Dansk Data Elektronik A/S

**Technical
Field Change Notes**

Updated 15th June 1994

Supermax Field Change Notice no. 92

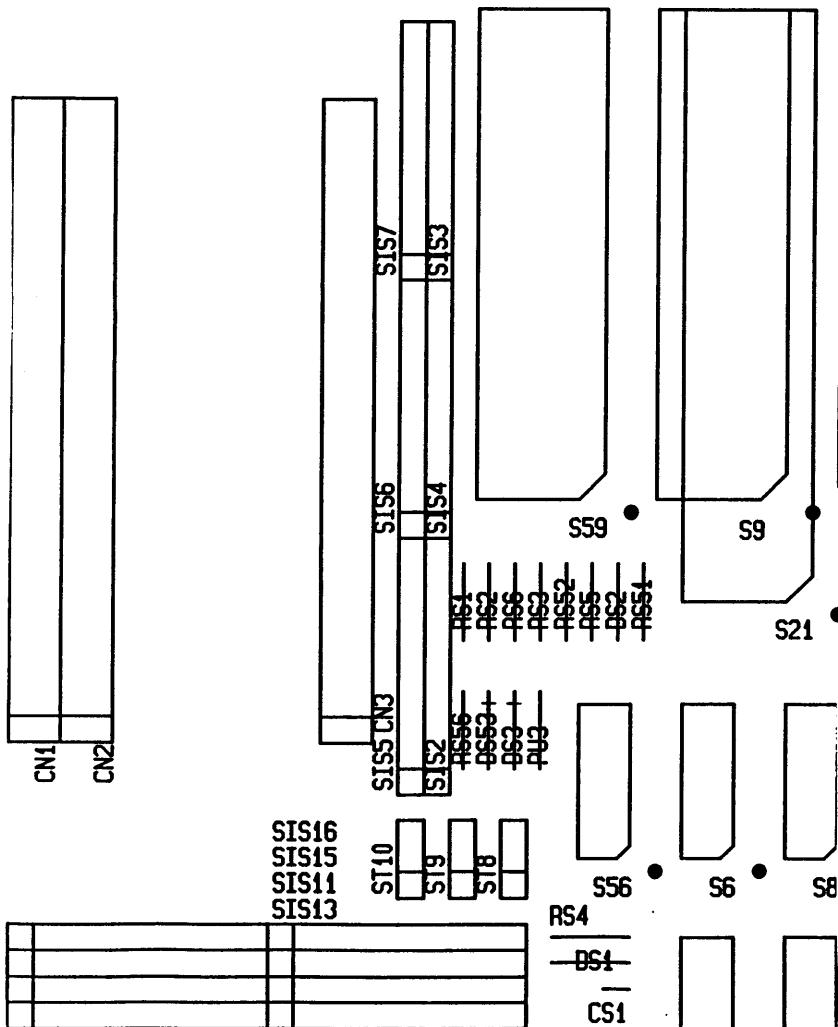
1. Replace diode DS3 and DS53 with 1N5818 types.
2. Connect strap ST10 pin 2 to connector CN3 pin 26 with insulated wire on the solder side of the PCB.
3. Strap ST8 provides termination power to SCSI interface 0. Set strap to short between pin 2 and 3.
4. Strap ST10 provides termination power to SCSI interface 1. Set strap to short between pin 2 and 3.
5. Update PCB revision field:
 - 4000 ISS 1: Update to revision G by removing the letter F in the PCB identification field.
 - 4000 ISS 2: Update to revision D by removing the letter C in the PCB identification field.

DIAC 4000 ISS 1 AND 2
COMPONENTSIDE.

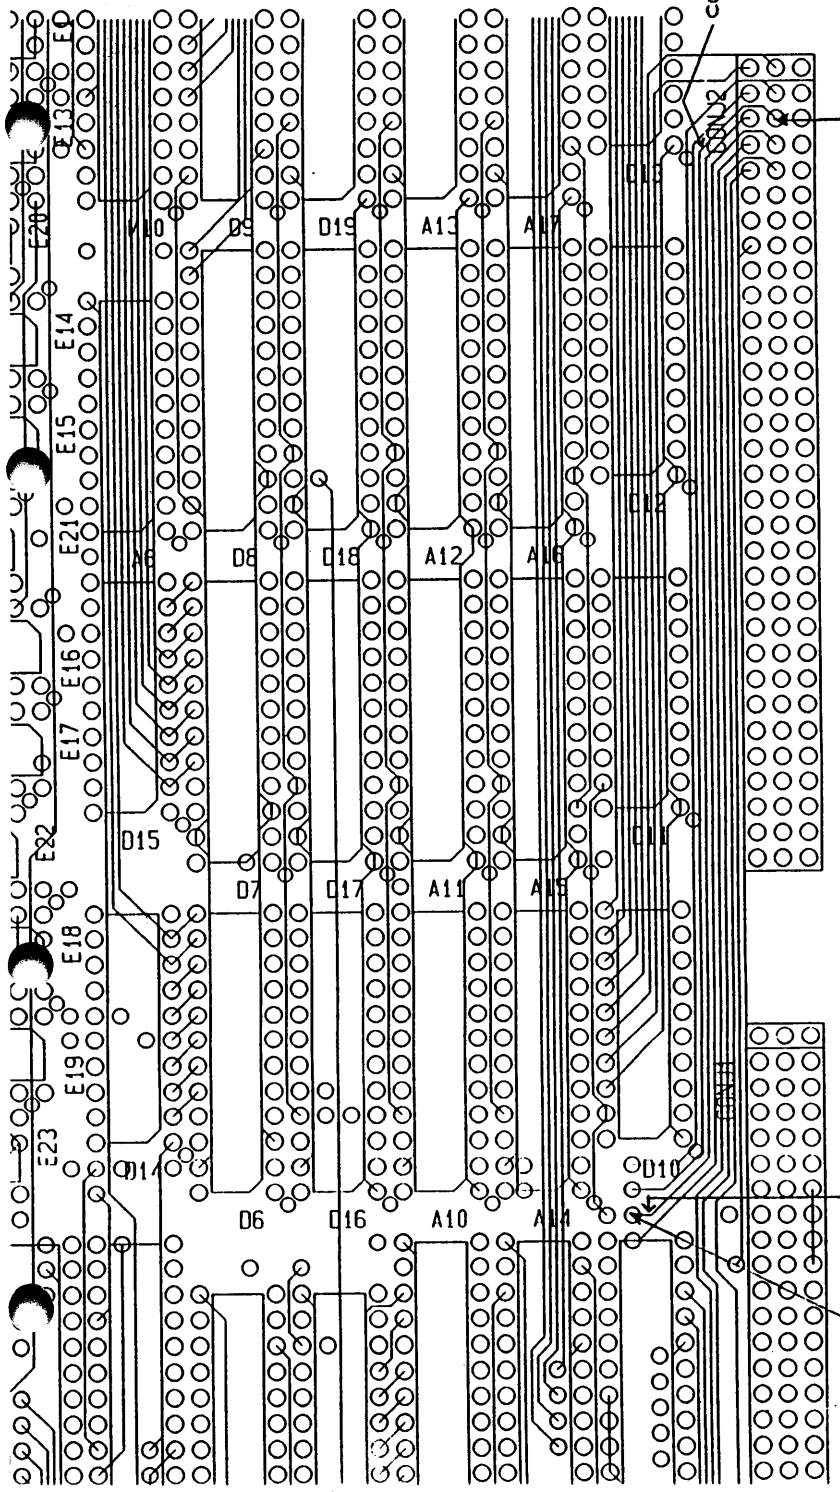
CONNECT WIRE

Figure 1.

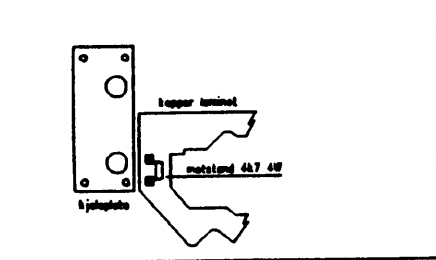
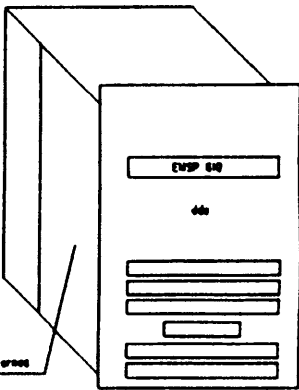
1. Remove the front left heat sink by removing 12 screws.
2. Mount the resistor 4k7 4W in the two empty holes in the PCB. See figure 1 for mounting details.
3. Secure the resistor on the PCB by using some silicone glue.
4. Mount the heat sink again.
5. Update the revision field on the front plate of the power supply from "empty" to B by writing a B in the revision field.

Supermax Field Change Notice no. 112

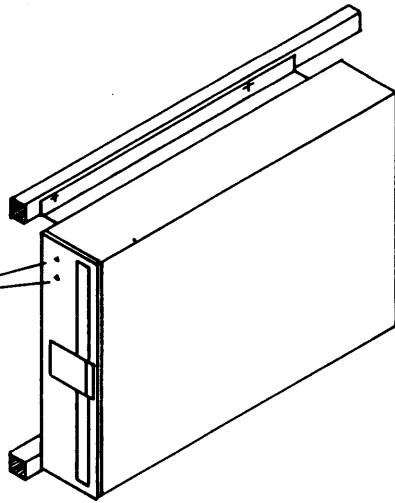
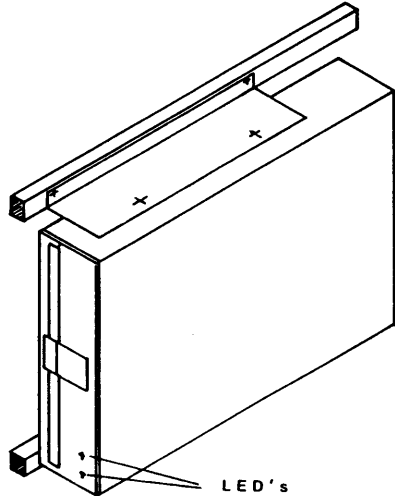
BEFORE CHANGE

AFTER CHANGE
